7.5 Block B - Residential Entrance

7.6 Block B - Appearance

7.7 Block C - Layout

Block B - Elevation

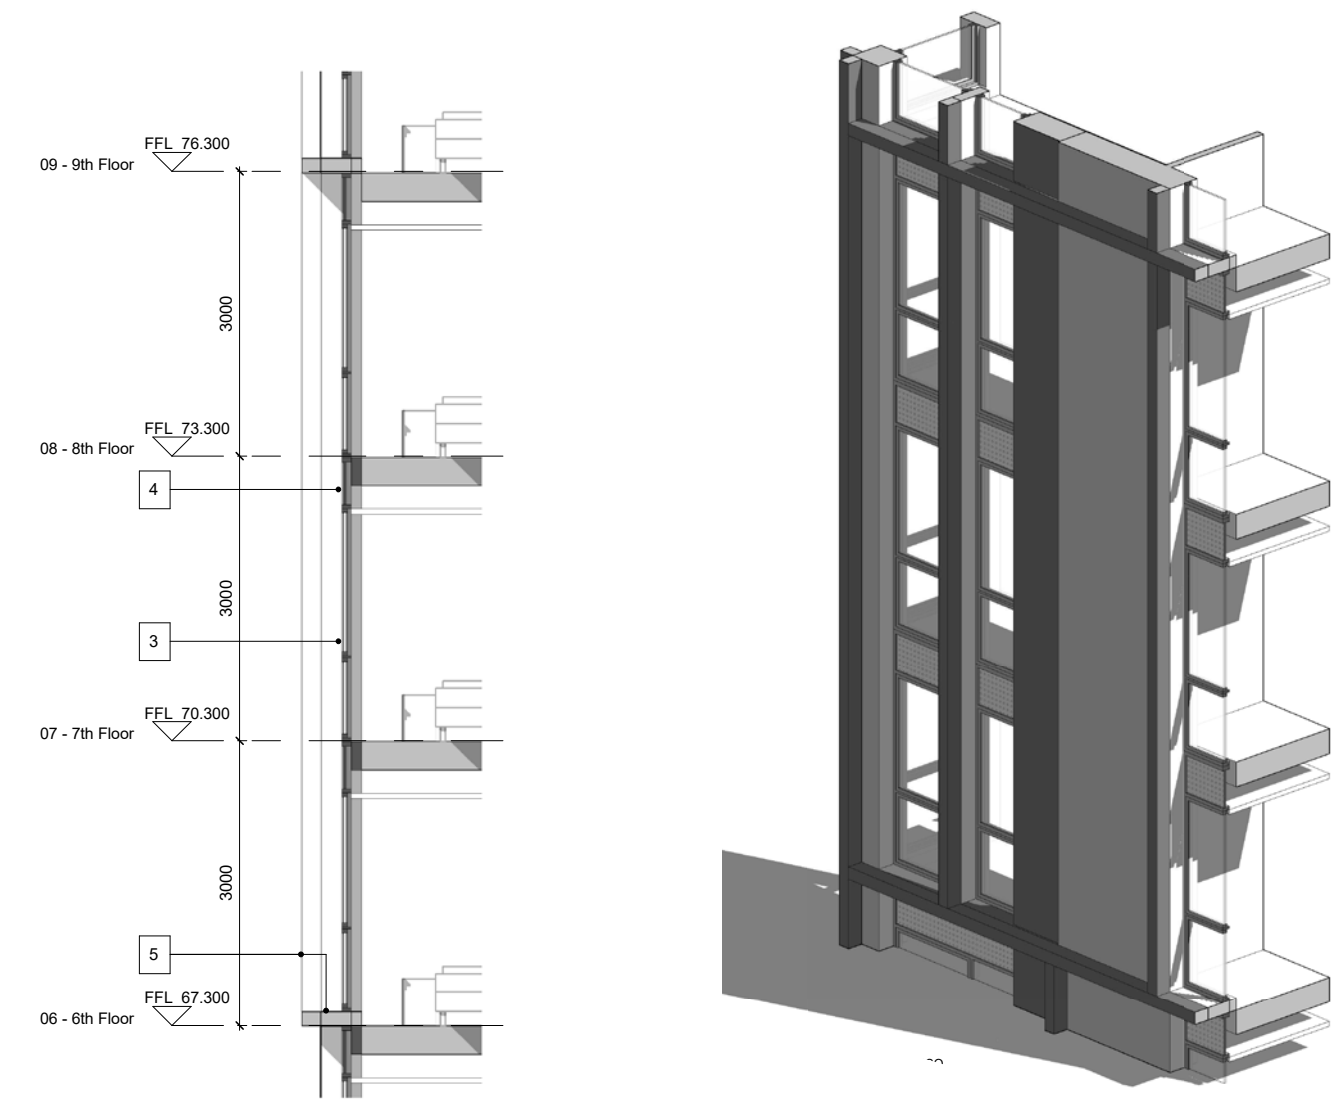
Comment:

“The journey from the street to residents’ front doors needs to be carefully considered, to ensure that the experience is one of a comfortable transition from a very public and likely busy space, to their private homes. They are not immediately legible or prominent to/from the street – for example, the only sign for those walking from Queen’s Walk to help them know their location might be the additional bolt-on canopy.”

- The proposed entrances could include a full height, perforated metal panel
- This will improve visibility on approach
- Could be back lit for night time legibility
- Generous width maintains quality amongst the adjacent retail uses

Site C - Residential Entrance

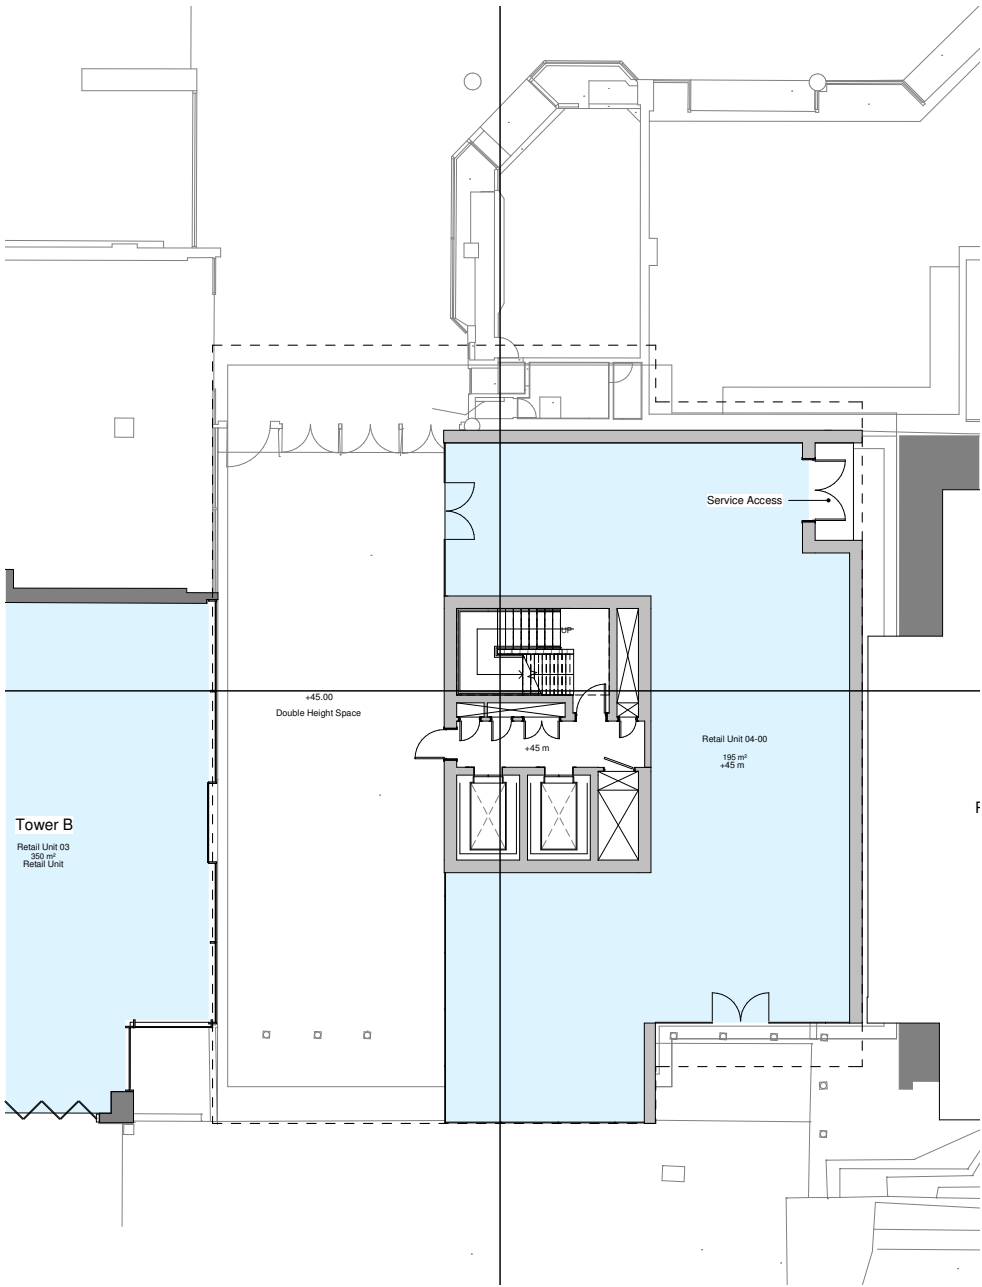
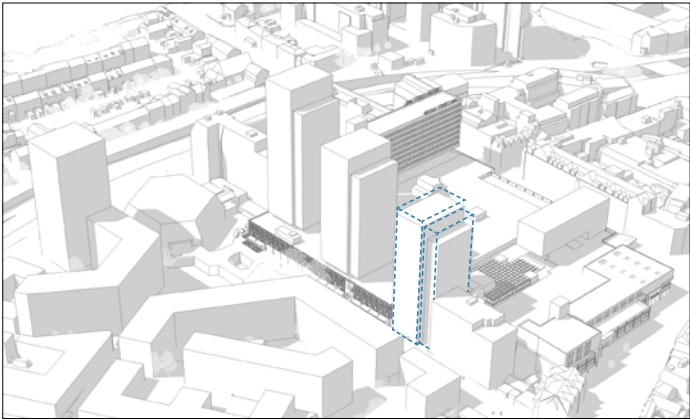
- Residential Access Door now inset to avoid door swing interfering with pedestrian traffic flow to and from centre.
- Inset to 'shoulder' of Block C pushed further Northwards in plan to allow for revised access to Hotel
- Circulation core reconfigured to improve layout

Site C - Residential Entrance

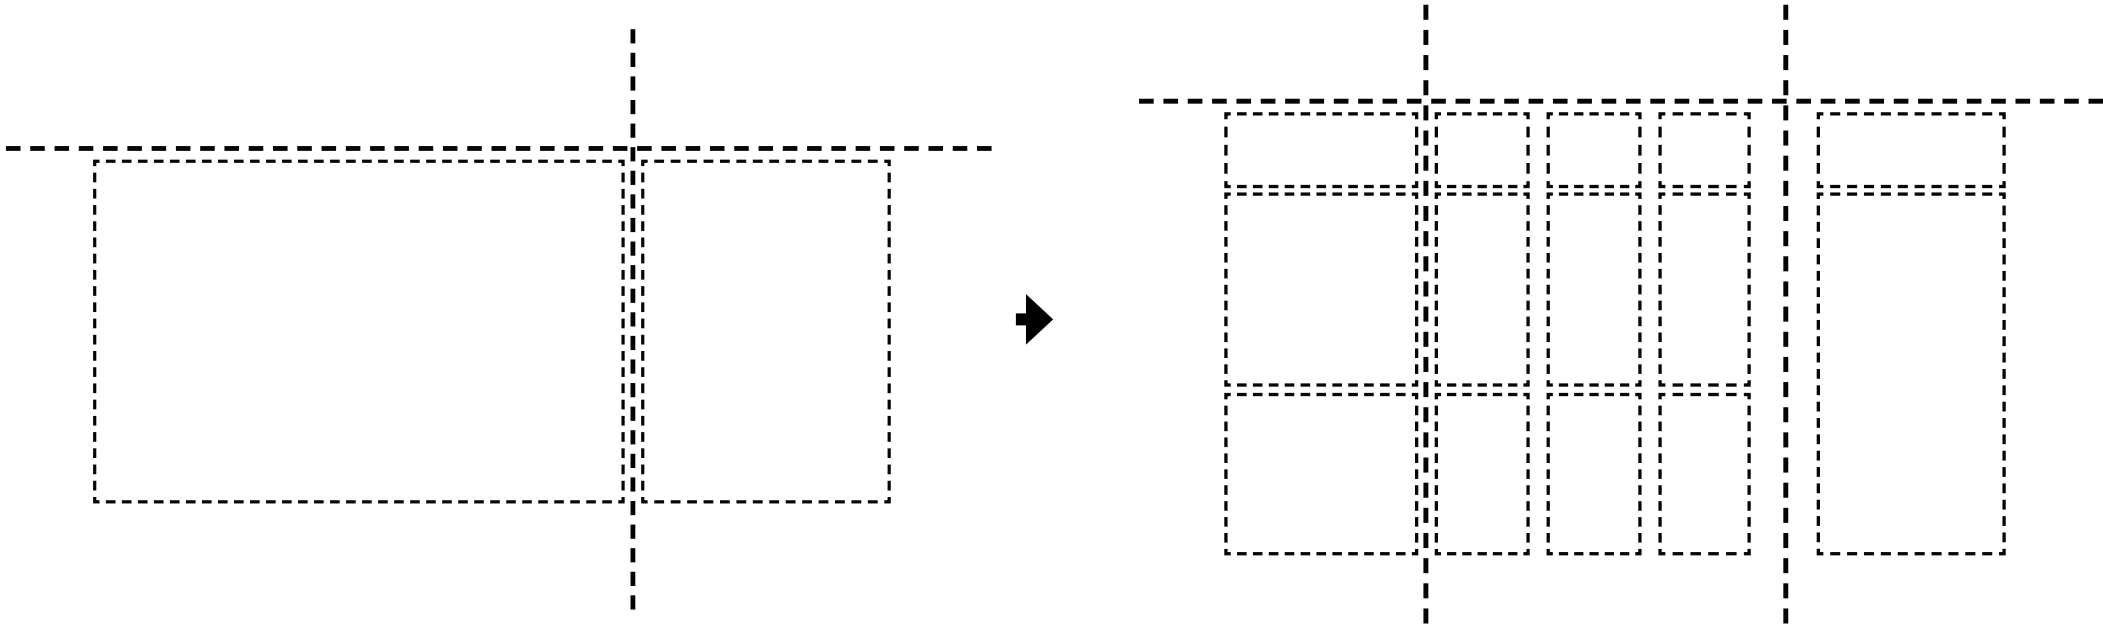
- The proportions of Block C's Elevation along Dusseldorf Way previously did not tie in with the existing shopping malls elevation. This was largely dictated by the AOD set by the amenity level
- The revised elevation is now grounded with pronounced columns and a chamfered fretwork panel detail that reflects the existing pattern of the Broad St Mall concrete frieze.

7.8 Block C - Appearance

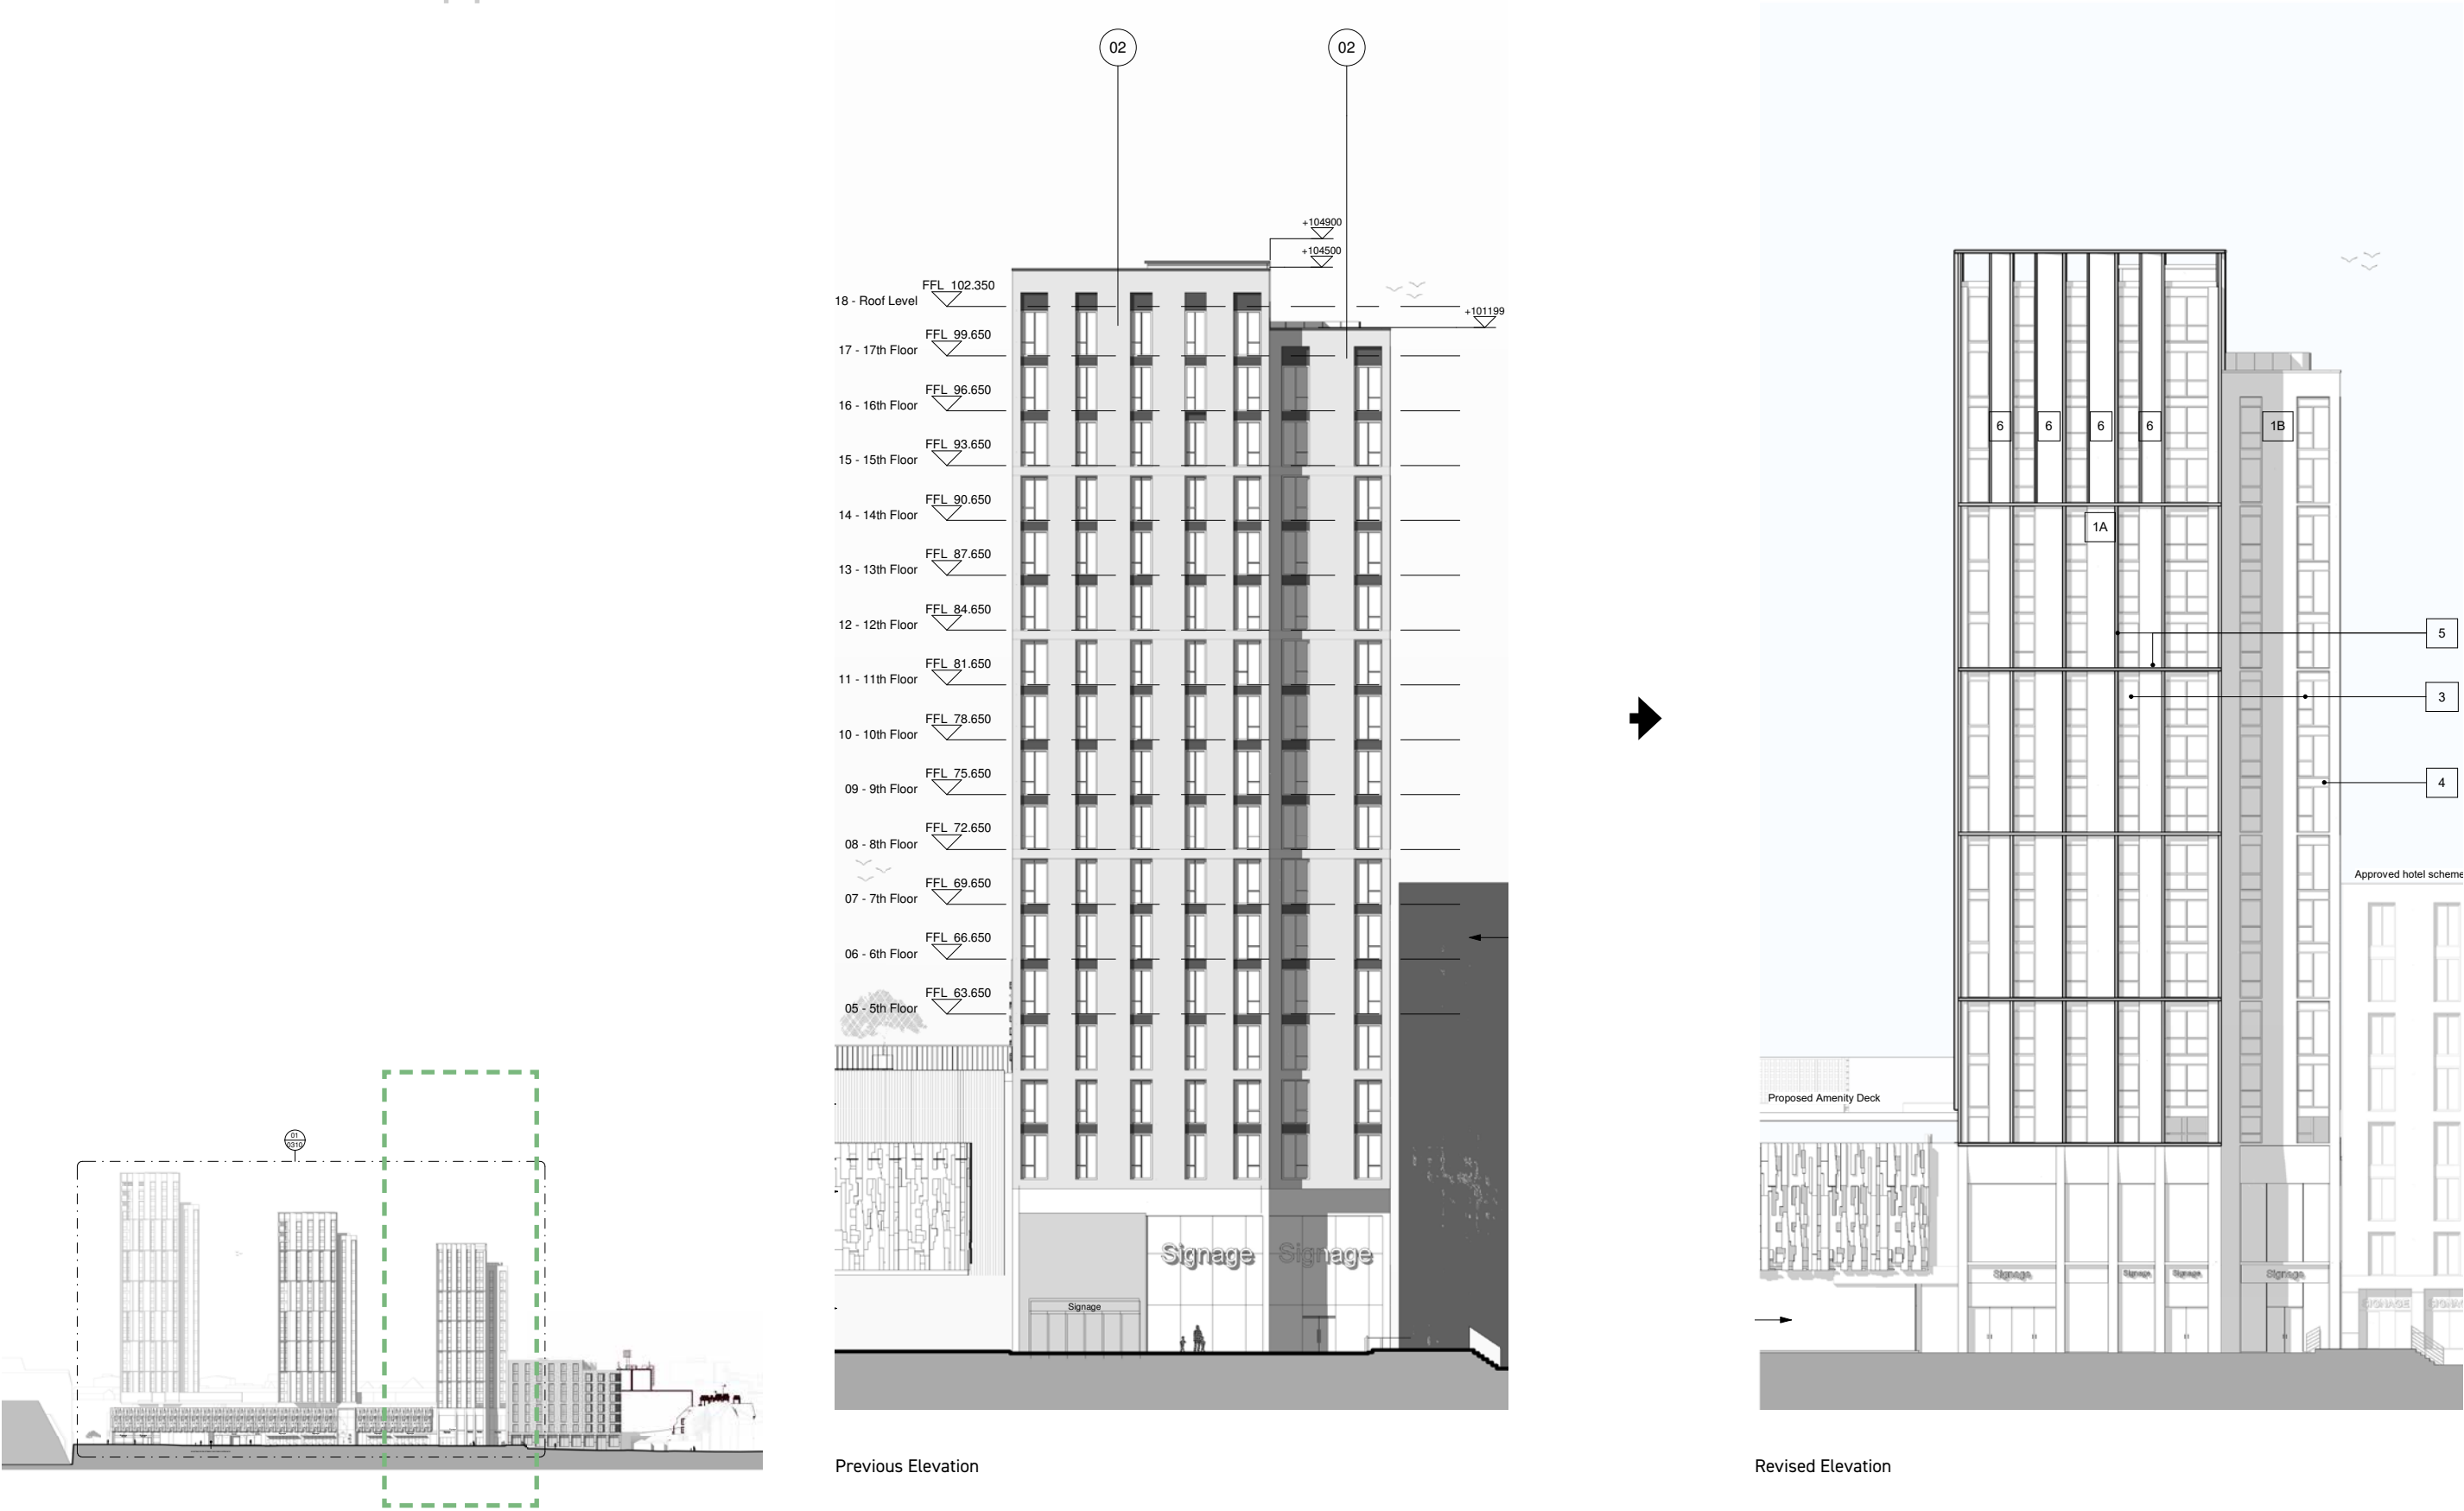
Comment:

"Where block C meets the existing shopping mall on the Hosier Street elevation is particularly weak. The elevation of the new tower does not respond to the existing elevation."

- Introduction of vertical bays within the facade to help ground the elevation and reduce the height of the entrance to the Mall
- Horizontal framing now aligns with existing concrete facade of car park helping to unify the architectural rhythm from existing to proposed
- Improved proportion of entrance to mall to human scale

Block E Plans

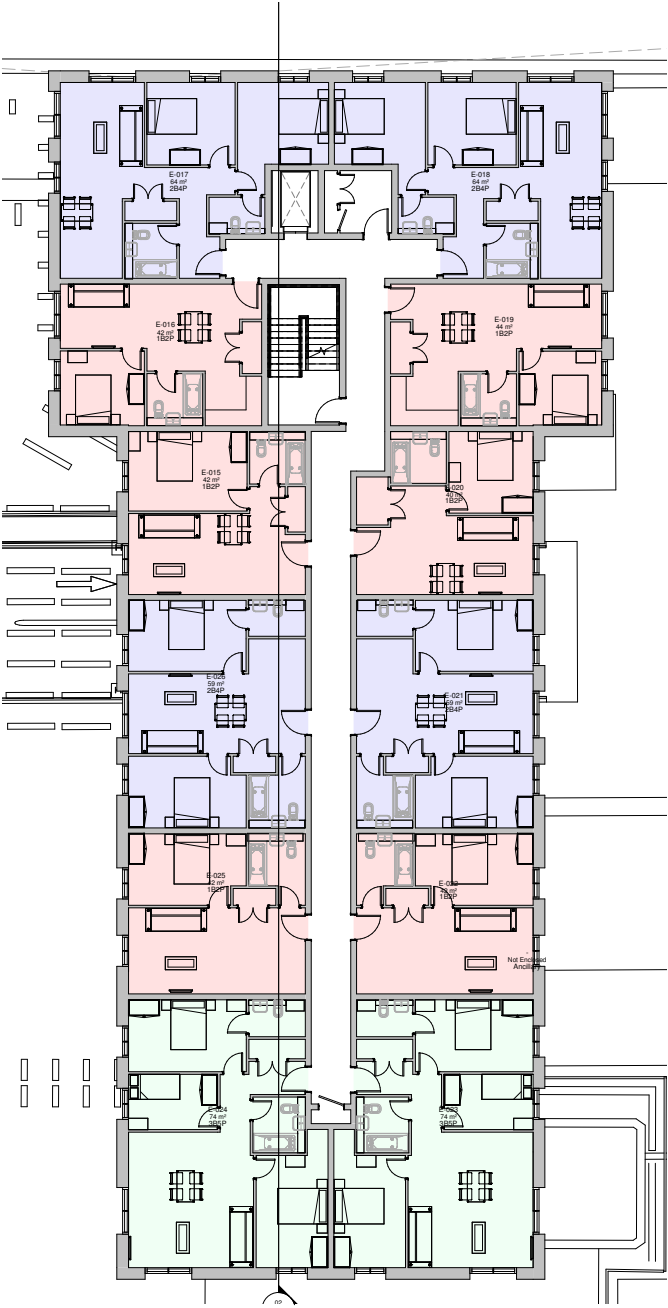
Comment:

“The rationale for the mass of block E, shaped as a hammerhead, is unclear and this block should be simplified into a simple, rectangular form in the same way as block D.”

- Block E along Oxford Road appeared wide in proportion and it was suggested that simplifying the mass and form of this block would help.
- Changes to the unit types in the North of the block have allowed for a more rational floor layout whilst also reducing the elevation width along Oxford.
- This also helps to reduce the cumulative visual impact along Oxford Road.

Site A Basement

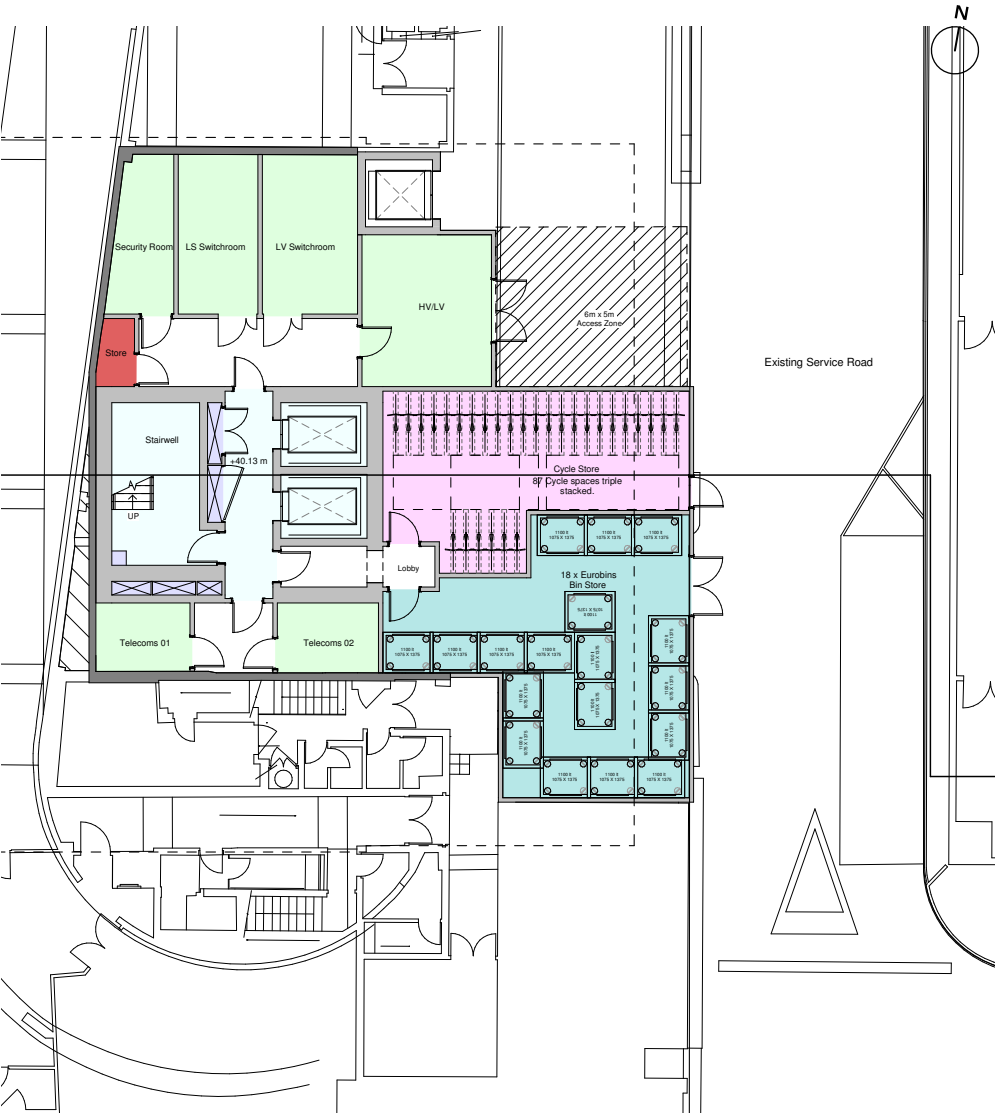
- Triple stacked cycle storage (Josta Triple Parker)
- Access door from refuse store now inset to not interfere with highways
- Inclusion of safety bollards
- changes to M&E requirements
- Servicing of retail unit above at this level
